NYCT COMPRESSOR DOOR IMPROVEMENT

Prevost vehicles

DESCRIPTION

FIG.4 NEW UPPER HINGE

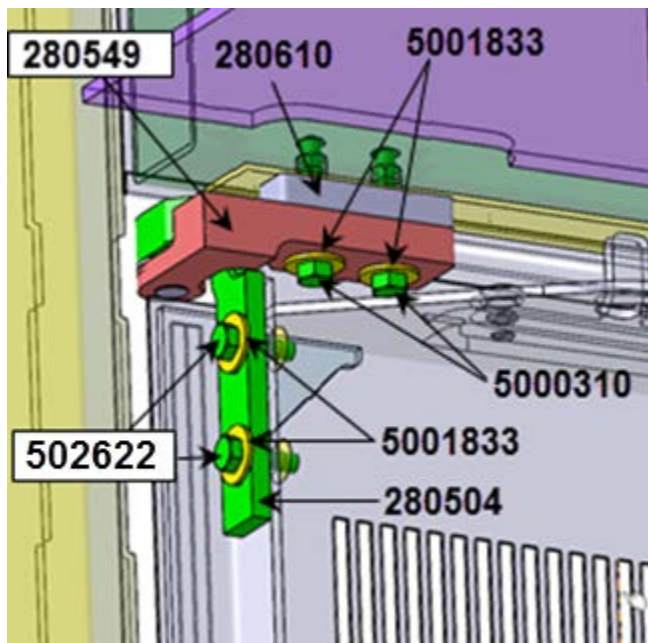
- 4) Install the new upper hinge (parts **280504**, **280549** & **280610** in kit Fig.4) making sure that:
- New M6 bolts and washers (**5000310** & **5001833**) are used at the upper (vehicle structure) mounting points (Fig.4).
 - New M6 bolts (**502622** & **5001833**) are used at the door mounting points (Fig.4).
 - A new plastic bushing **284607** is installed at the pivot point (Fig.5).
 - The door is fully supported by the *lower hinge* and not slightly lifted-up by the lift table so there is no gap between parts at the lower pivot point (Fig.6).
 - There is no gap between the upper and lower part at the pivot point of the upper hinge (Fig.7).
 - The four M6 bolts are torqued to **68 lb-in** (apply blue Loctite 242 or equivalent medium strength thread locker on all fastener threads (Fig.8)).

FIG.12 NEW VS OLD LOWER HINGE PARTS

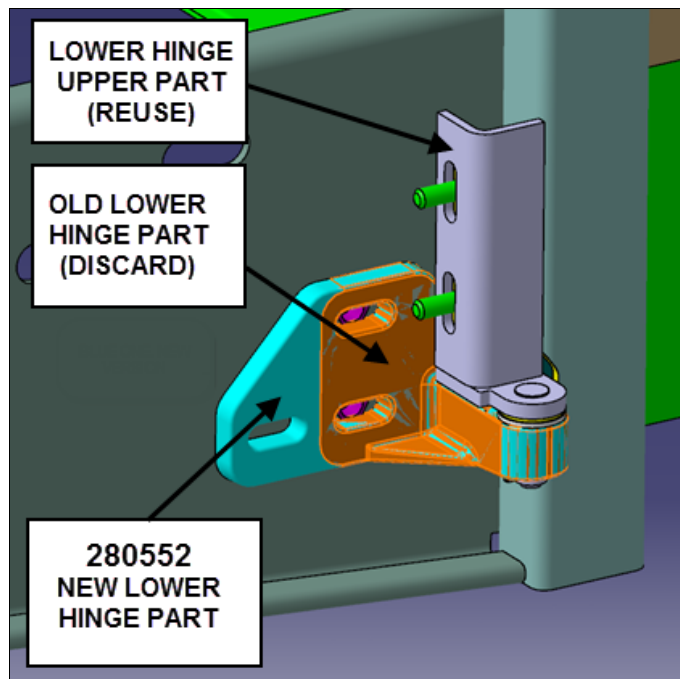
- 4) Discard the *lower* (vehicle structure) part of the lower hinge and replace it with the new **280552** part supplied with the kit (reuse the door part of the hinge but discard hardware Fig.12).

FIG.15 NEW HARDWARE TO BE INSTALLED - LOWER HINGE

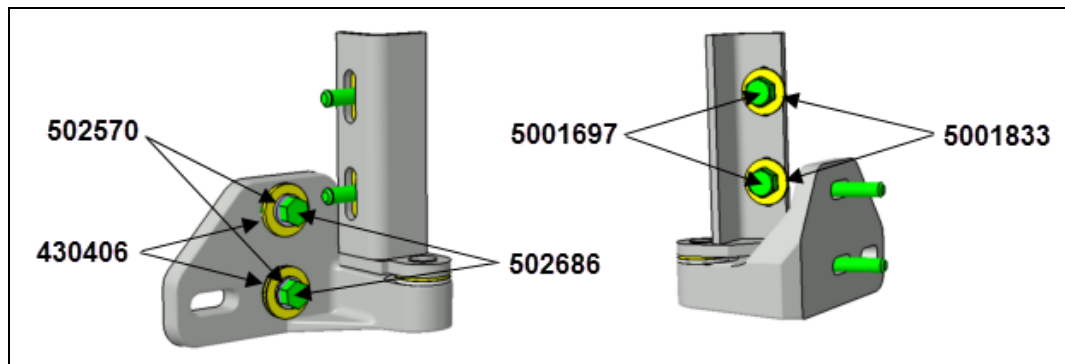
- New plastic bushing **284607** and washer **502723** are installed at the pivot point (Fig.13).
- Door is fully supported by the *top hinge*, not the lift table (no gap at the pivot point) (Fig.14).
- New M6 bolts and washers (**5001697** & **5001833**) are used at the door mounting points (Fig.15).
- New M6 bolts, locks & washers (**502686**, **502570** & **430406**) are used at the vehicle structure point (Fig.15).
- All four lower hinge bolts (vehicle *and* door frame) are torqued to **68 lb-in** (apply blue Loctite 242 or equivalent medium strength thread locker on all fastener threads (Fig.16)).

FIG.17 COMPRESSOR DOOR HORIZONTAL & VERTICAL GAPS

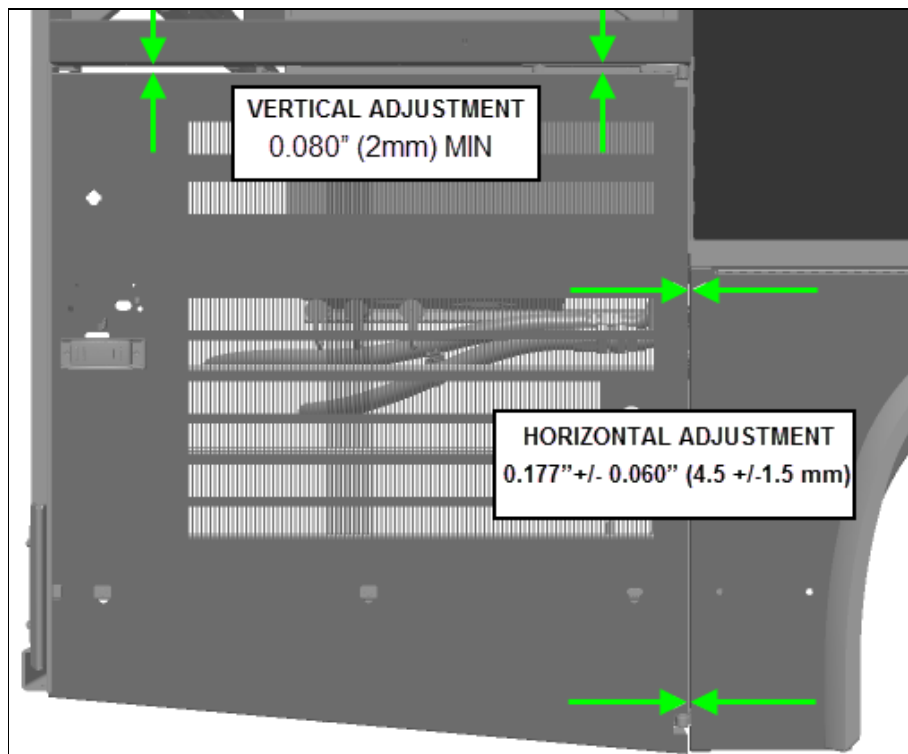
- 6) Remove door support installed at step 2 and open and close the door several times to make sure it is working properly, check door top and side adjustments. There should be an even (parallel) gap of at least 0.080" (2mm) at the top of the door and a 0.177" +/- 0.060" (4.5 +/- 1.5 mm) gap between the door and the vehicle rear fender (Fig.17).

If gap is out of spec the compressor door may be adjusted for proper fit by untightening hinge bolts:

- *Loosen the bolts holding the hinge to the vehicle structure to shift the door horizontally LEFT or RIGHT.*
- *Loosen the bolts holding the hinge to the door frame to shift the door vertically UP or DOWN.*

FIG.19 LOWER HINGE 3rd BOLT HOLE

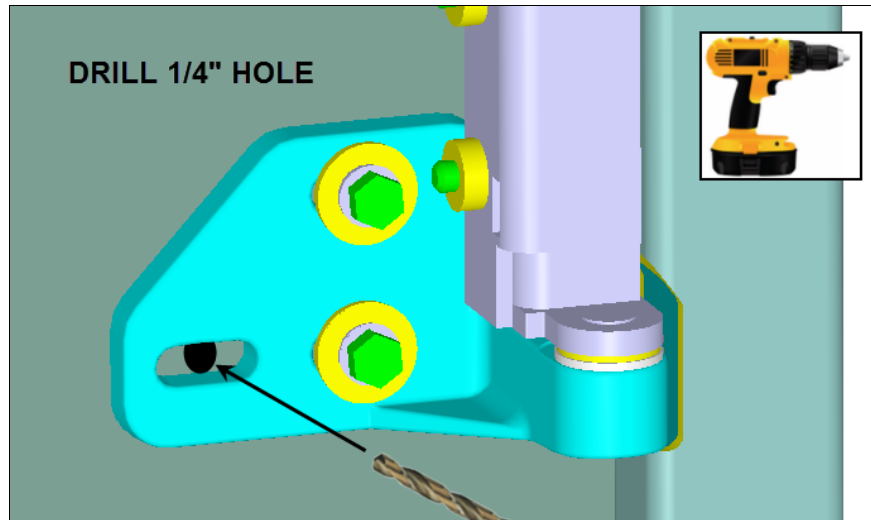
- 8) Drill a 1/4" hole in the middle of the lower hinge 3rd slot (Fig.19).

FIG.20 LOWER HINGE BOLT INSTALLATION & TIGHTENING TORQUE

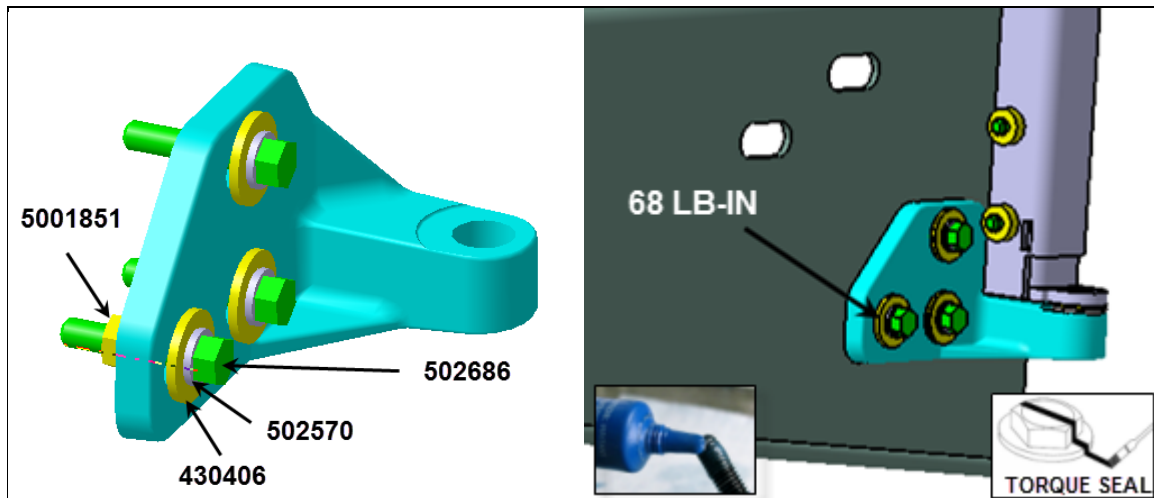
- 9) Install the supplied bolt **502686**, nut **500851**, washer **430406** and lock washer **502570** in the previously drilled hole, Apply medium strength threadlocker and torque to **68 lb-in.** Apply a stripe of tamper proof indicator paint (torque seal) to the bolt head (Fig.20).

FIG.24 REINFORCEMENT PLATE POSITION

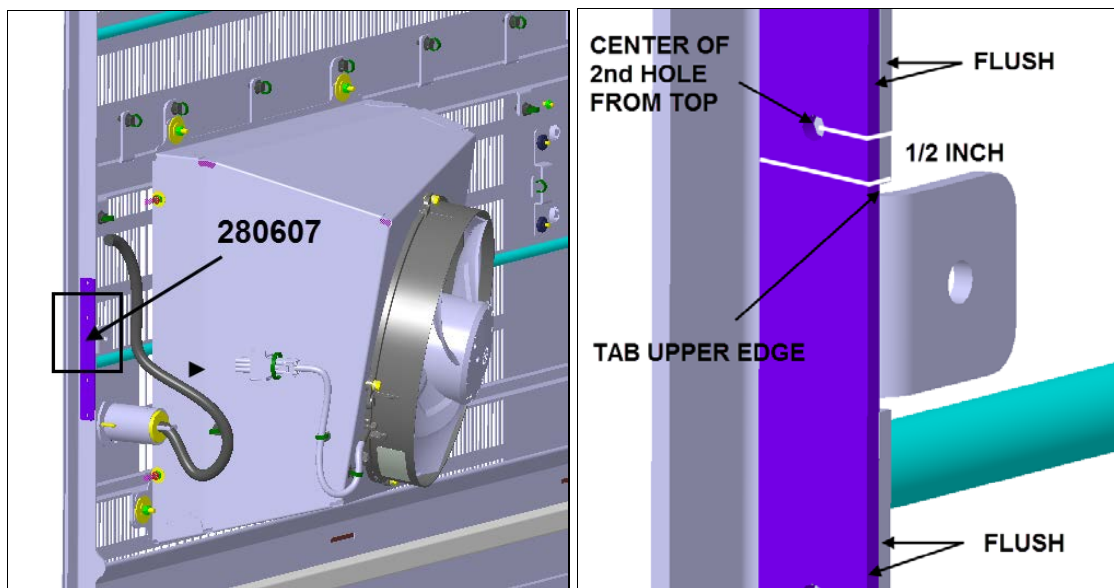
- 4) Position the **280607** door reinforcement plate 2nd hole from the top at 1/2" from the door frame tab upper edge and *flush with the edge* of the frame (Fig.24).

FIG.27 RIVETING THE PLATE

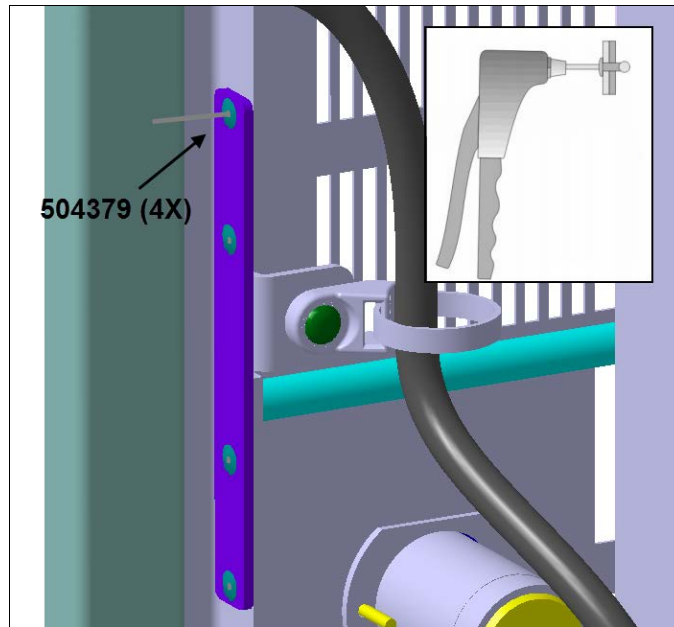
- 7) Using the 4 supplied **504379** 3/16" POP rivets and suitable hand riveter (POP rivet gun); rivet the plate to the door frame (Fig.27).
